Bell Helicopter **TEXTRON**

**INFORMATION LETTER 212-01-42
412-01-42
412CF-01-6**

SUBJECT: ENGINE ACCESSORY GEARBOX OIL DRAIN VALVE P/N 209-062-010-001, INSTALLATION OF

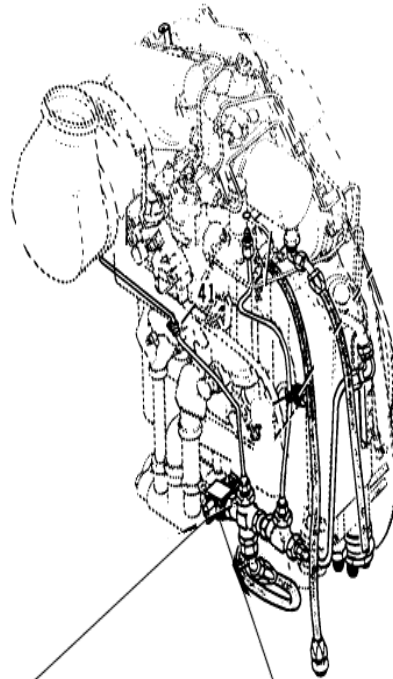
An incident involving loss of engine gearbox oil in flight has revealed that during installation of subject valve the wrong part number packing was installed causing the oil leakage. After review of the Illustrated Parts Breakdown it was discovered that an error had occurred stating no packing in this location or wrong part number.

Currently the Illustrated Part Breakdown Manuals are being revised to show the changes. Refer to attach figure showing the potential problem.

Missing Packing

Wrong Part Number

BHT-212-IPB
CHAPTER 71-99-00
Figure 71-16, Page 76
Packing Required P/N M83248/1-908

BHT-412-IPB
Chapter 71-99-00
Figure 71-8, page 47
Packing Required P/N M83248/1-908

C-12-146-000/MY-001
Chapter 71
Figure 71-8 (Sheet 1 of 3), Page 71-38
Packing Required M83248/1-908
